**CHANGE ORDER**

PROJECT: Ledyard Center Streetscape	CHANGE ORDER NUMBER: 001
CONTRACTOR: Pazz Construction	DATE: 04/7/2016

# Norfolk Style Decorative Pole

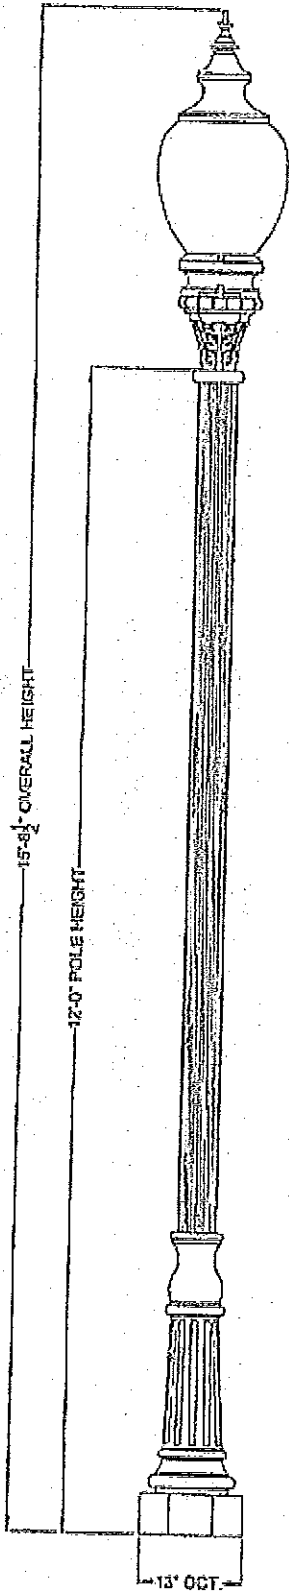
1. 20 light poles changed to Norfolk style decorative pole in lieu of original specified light poles. See attached specifications.

CATALOG NO.:	K116R-B3AR-V-03(SSL)1038-120V-K14-QFCI-SST
STYLE:	WASHINGTON LED ACORN SOLID SPUN TOP
GLOBE MOUNTING:	ROTALOCK
OPTICAL SYSTEM:	DAFFLED ARRAY ACRYLIC RIPPLED
IES CLASS:	TYPE V
INPUT WATTAGE:	89W SOLID STATE LIGHTING
SERIES:	1038
CCT:	5000K
LINE VOLTAGE:	120/277V
POLE ADAPTOR:	K14
PANT:	TEXTURED BLACK
OPTIONS:	QUICK DISCONNECT
QUANTITY:	10

CATALOG NO.:	AGDP-H-12
STYLE:	NORFOLK
POLE HEIGHT:	12'-0"
BASE:	13" OCTAGONAL
THICK:	3-1/2" O.D. x 3" TALL
MATERIAL:	HEAVY WALL CAST ALUMINUM 356 ALLOY SHAFTS 5" O.D. FLUTED EXTRUDED ALUMINUM
ACCESS DOOR:	LOCATED IN BASE
ANCHOR BOLTS:	1/2" x 24" x 3" HOOK WASHERS, 4 NUTS INCLUDED FULLY GALVANIZED
BOLT PROJECTION:	3" ABOVE FOUNDATION
BOLT CIRCLE:	9-1/2" DIAMETER
FINISH:	GLOSS BLACK
QUANTITY:	10
